HEGNPG

Places for People revised planning applications - your response

Community Zoom presentation
11th January 7-8.30pm

Advice from our Highways consultant

Bus Strategy

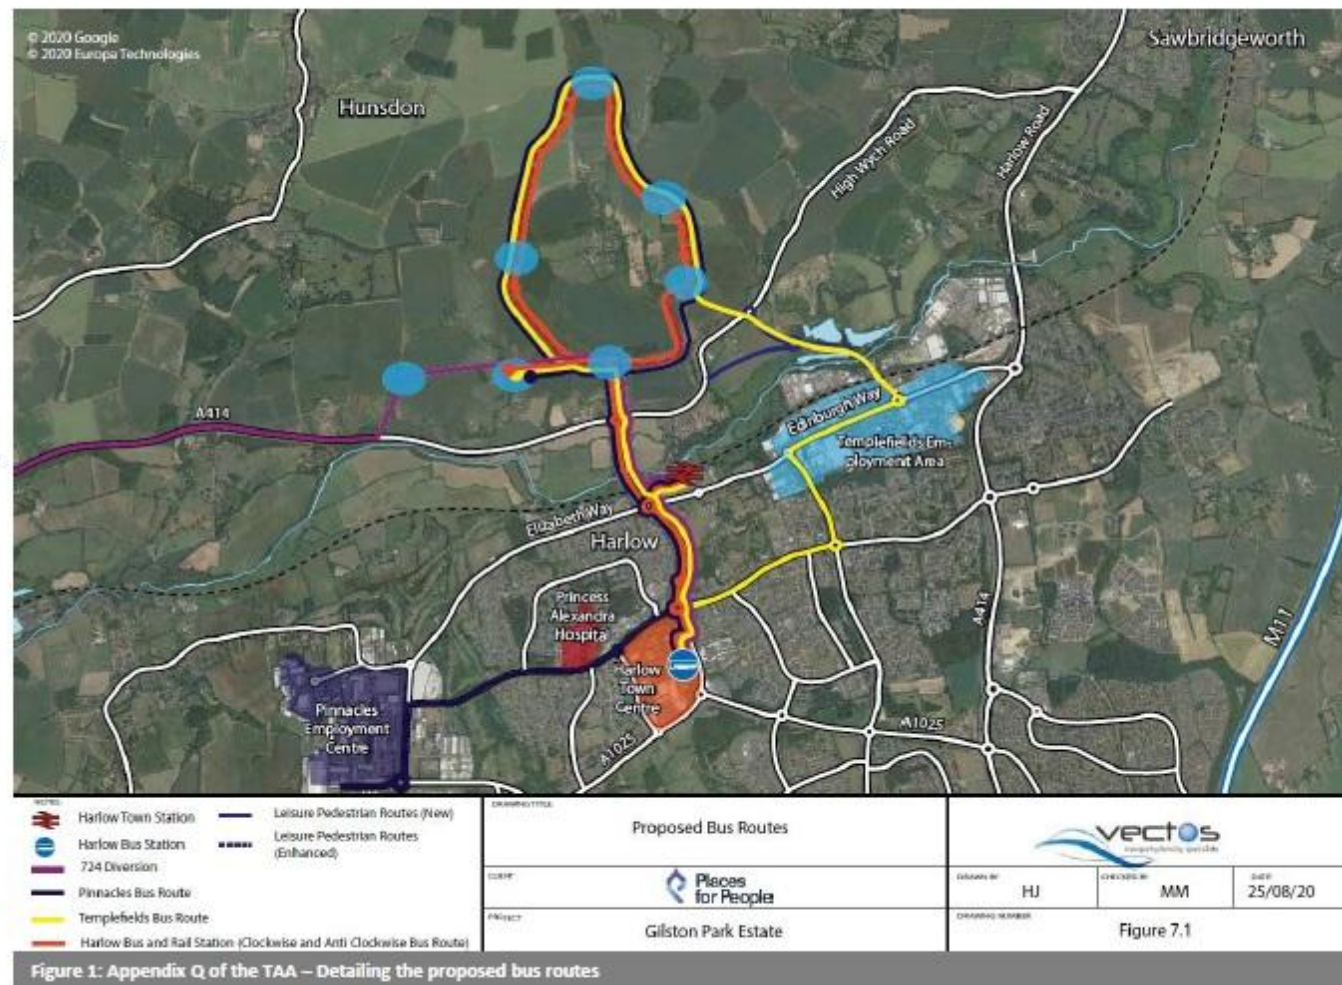
The applicant has clearly undertaken further, relatively extensive work to understand the number of trips and the circulation of buses associated with the masterplan. The number of buses proposed exactly matches the forecast number of trips, therefore whilst anticipated frequency is reasonable it does not seem overly ambitious. There is also limited detail regarding service provision outside of the peak and at weekends, which are also critical to ensuring their mode share targets are achieved. The application makes it clear the pump priming of the bus service would be necessary but makes limited reference to by how much / what amount.

How would the applicant ensure additional buses were provided should demand exceed 15 buses per hour at peak?

What assurances are there that a high quality reliable bus service is also available outside of the peak?

The NPG should be sure to make sure sufficient mechanisms are made within the S106 so that additional buses can be secured in the future.

Rail Strategy (1)

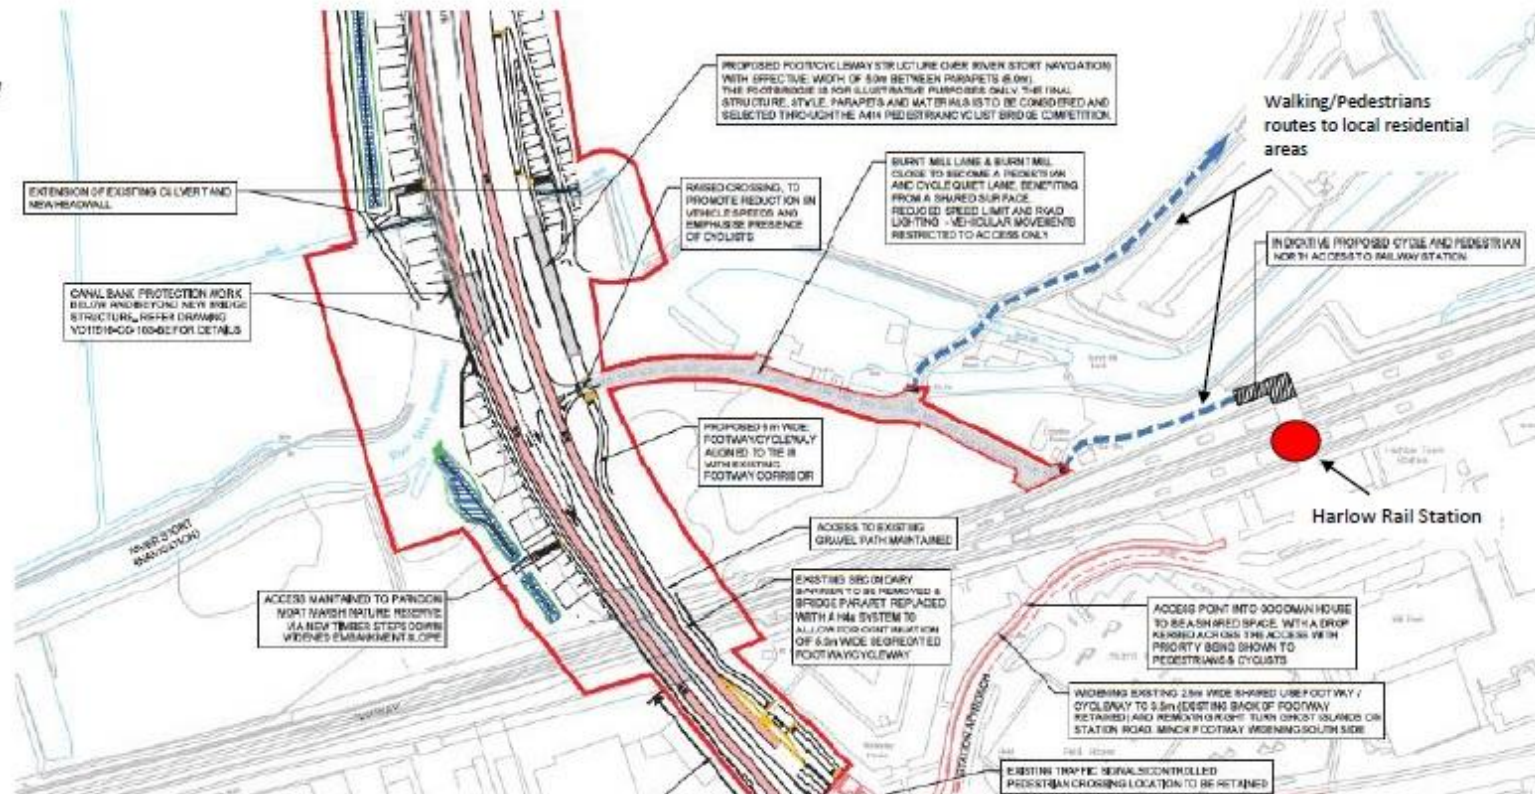
Whilst it appears as through further work has been undertaken in relation to the Northern Station access, the commitment made by the applicant towards it is still minimal and caveated with, if it is feasible. The application makes reference to the fact that without the Northern Station access the development impact is acceptable – i.e. it is not essential and/or a requirement.

We suspect this is a means of ‘watering down’ any commitment in the future.

When will the feasibility of the Northern Station access be known? – this has clearly not been answered since the original application (one might argue this a key point and it appears as though very limited additional consideration has been given to this over the last year).

Figure 3: Associated traffic movements and increased severance with the introduction of a dual carriageway

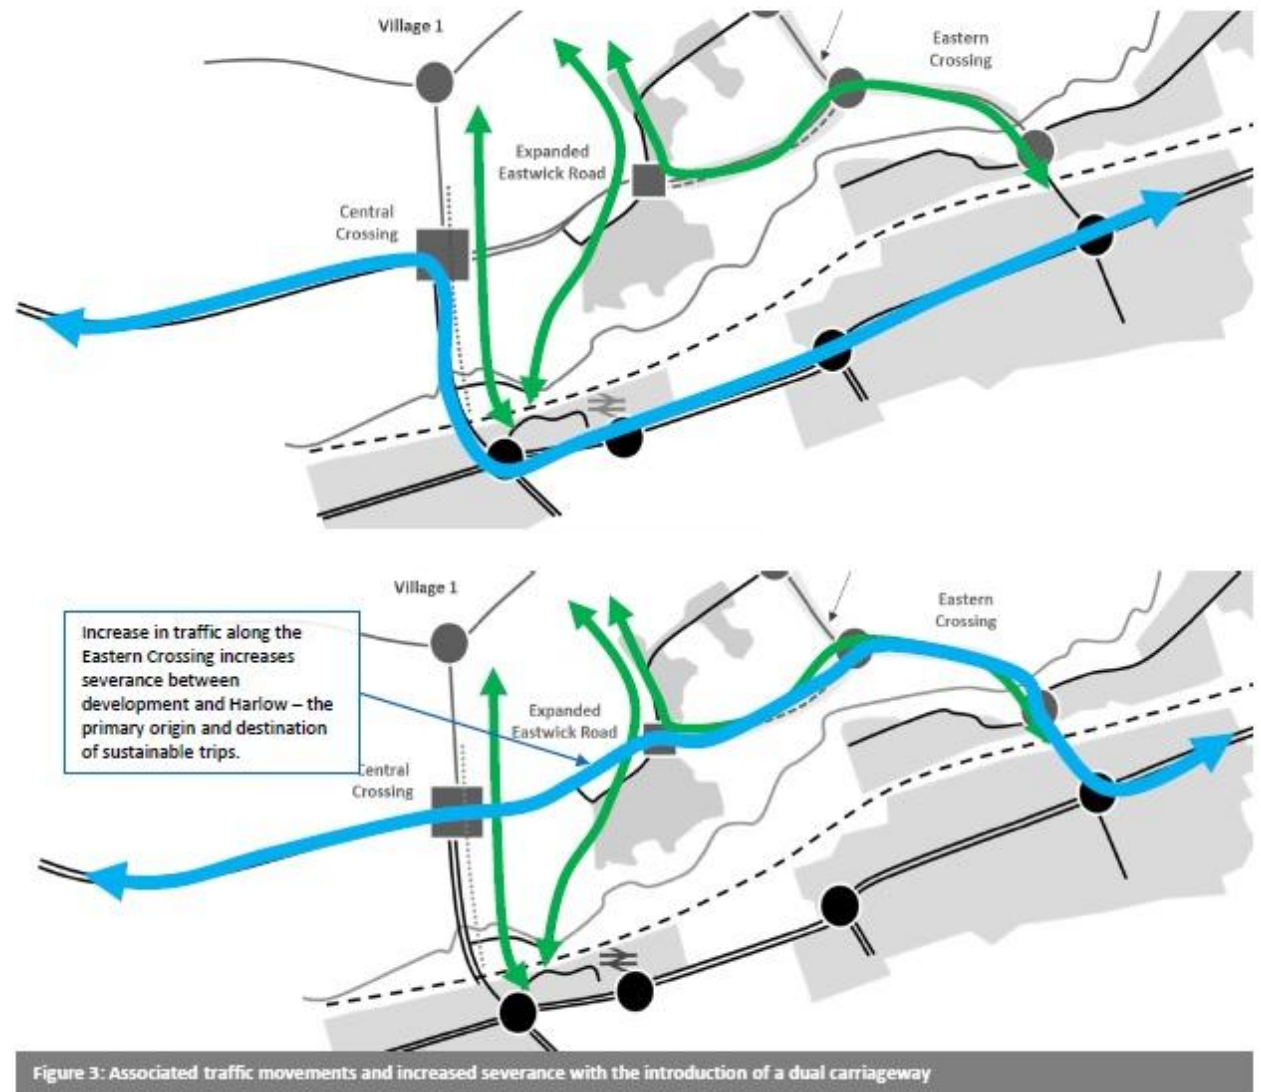
Clearly a slight change of angle from the previous application, with the applicant admitting that the Stort Crossings are not exclusively a means of mitigating the impact of the development. The above paragraph demonstrates that the Eastern Crossing is being used, in part at least, to relieve traffic in central parts of Harlow.

Its an interesting argument stating that this specifically assists sustainable modes. The Eastern Crossing, as we have always said, will result in a greater number of trips increasing severance between the development and existing facilities within Harlow as outlined in Figure 3.

By diverting vehicles away from the centre of Harlow towards the Eastern Crossing (between the development and Harlow station(s) and other town facilities), isn't this simply increasing severance between the development and Harlow, potentially reducing the likelihood of sustainable trips between the site and Harlow?

Figure 6: Final junction arrangement plans for Village 1's Central Access, this is bus only, plans provided by Vectos

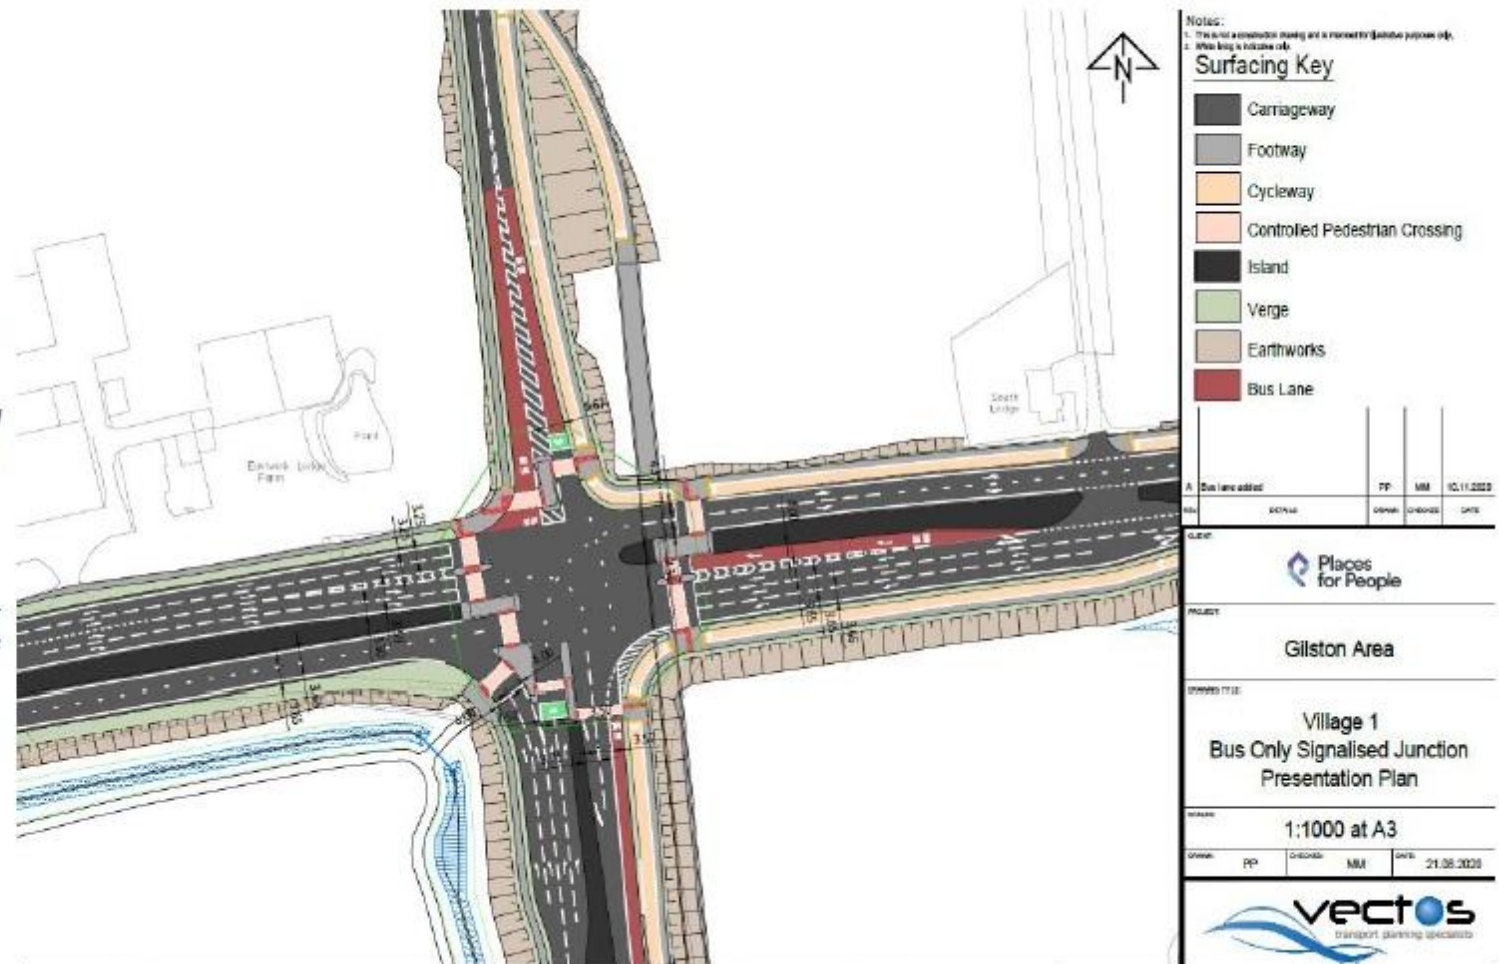
A large number of lanes is going to drive further severance between the site and Harlow and it is clear that at grade crossing facilities here are unlikely to be attractive to pedestrians and cyclists.

It is also clear from the TAA, that highway authorities are seeking to drive greater number of trips through the new Central and Eastern Crossings with the aim of reducing the number of trips within Harlow. This highlights the concern highlighted previously about delivering a by-pass by stealth.

Interim Village 1 Access – Eastern Access

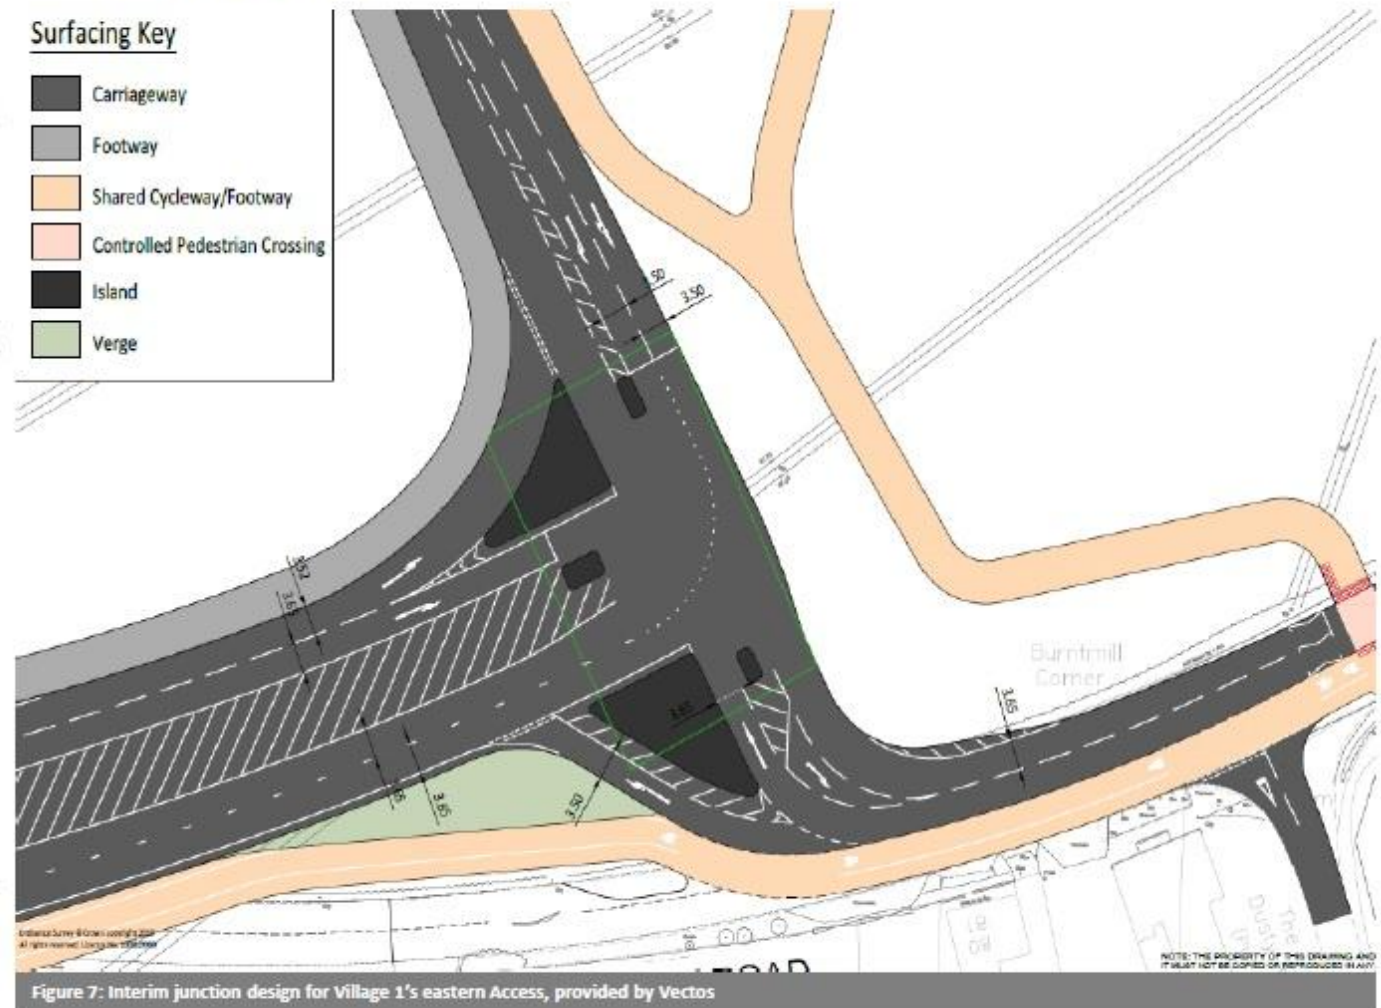
The new Village 1 Eastern Access creates an additional junction within the green belt over and above the original application driven by the sustainable bus corridor. The theory behind a sustainable bus corridor is laudable, but all it really does is shift traffic towards this junction, so arguably doesn't really improve sustainable credentials – just shifts vehicle traffic further east whilst delivers even greater amount of 'tarmac'.

Whilst the NPG support the sustainable transport corridor in theory, surely it only 'works' if it discourages vehicle trips? – this application simply provides the same means of access as the original application just with an additional junction further to the east resulting in greater land requirements and additional turning movements at two junctions beyond the original application?

How much additional land is required in delivering the Village 1 Eastern Access beyond the original application?
